IDAP REPORT

Property:	21 Cameron Street STRATHFIELD Lot: A DP: 399504 DA2022.98
Proposal:	Demolition of existing structures on site and construction of a two-storey dwelling with basement and swimming pool.
Applicant:	H.A Design Group Pty Ltd
Owner:	R Zhu & R Wang
Date of lodgement:	30 May 2022
Notification period:	6 June 2022 – 20 June 2022
Submissions received:	Nil
Assessment officer:	J W Brown
Estimated cost of works:	\$1,208,335.00
Zoning:	R2-Low Density Residential - SLEP 2012
Heritage:	No
Flood affected:	No
RECOMMENDATION OF OFFICER:	Approval

Figure 14: Turning template

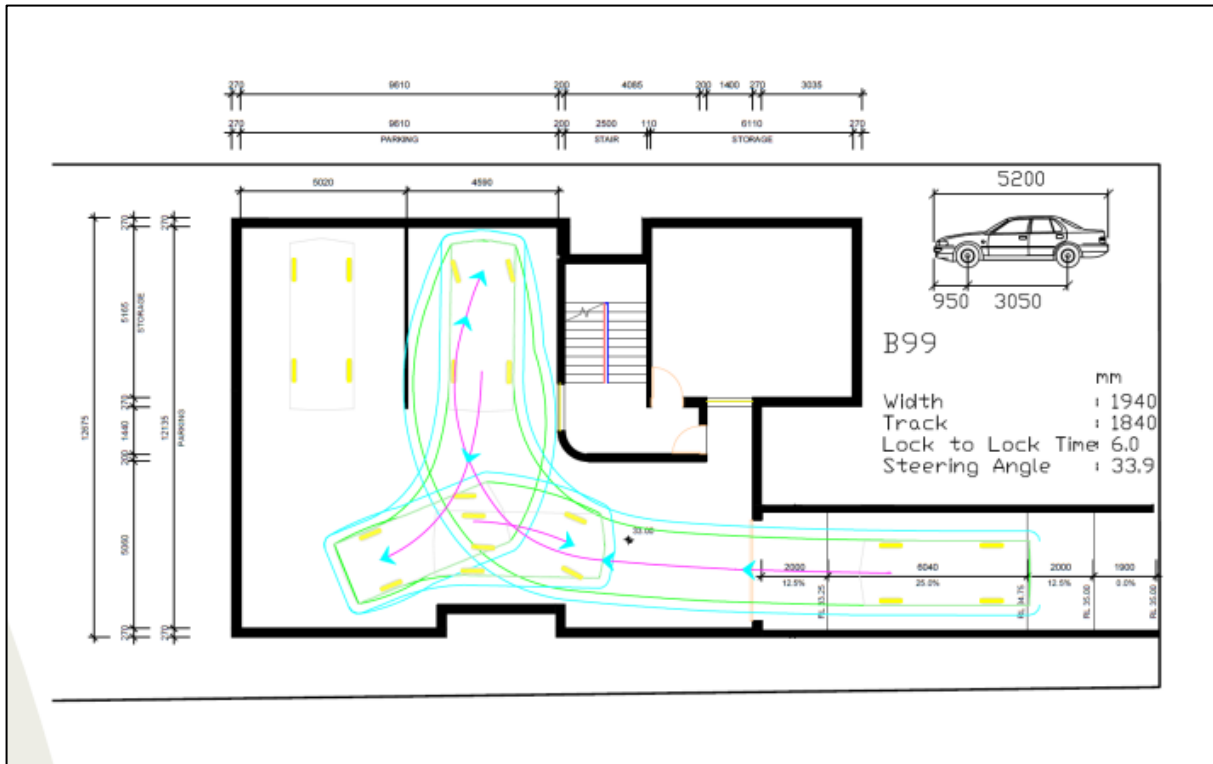
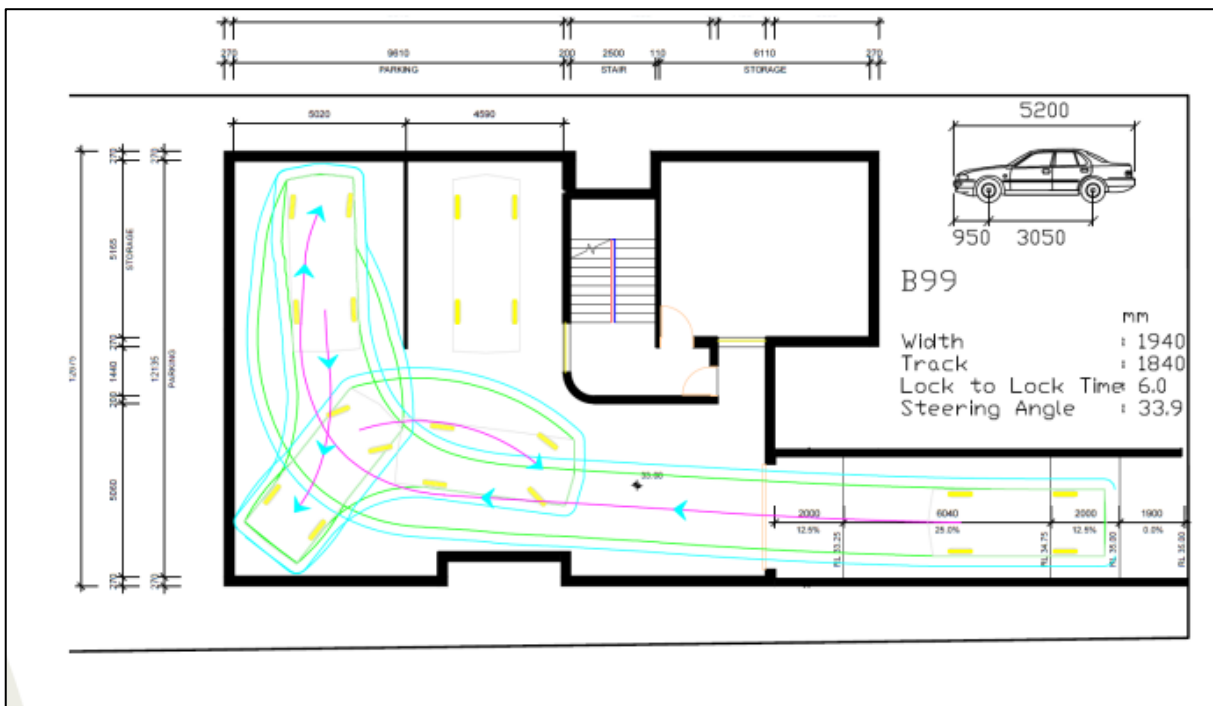
The plans suggest that the parking and manoeuvrability of the basement is larger than what is required. The applicant provided turning templates (Figures 14 and 15) showing that the entire area is needed for vehicles to enter and exit in forward direction. Further Council's Traffic Engineer reviewed these templates and suggested that the basement should not be reduced any further. Therefore, the basement size for parking and manoeuvrability is acceptable in this circumstance.

The ramp to the basement is wider than the 3.5m requirement and the width of driveway at the boundary is greater than 3m. Both of these will be conditioned in the consent to be complied with. The storage room will also be conditioned to have a floor to ceiling height of 2.1m to reduce the risk of it being used for habitable purposes.

Update Plans	The stormwater plans need to be updated to correspond with the current architectural plans.
Front Fence	The front fence's solid component must be reduced to 0.7m in compliance with SCDCP 2005
Basement Storage Room	The basement storage room must have a floor to ceiling height no greater than 2.1m.
Basement Ramp and driveway width at boundary	The basement ramp must be a maximum of 3.5m and the driveway at the boundary must be a maximum of 3m.
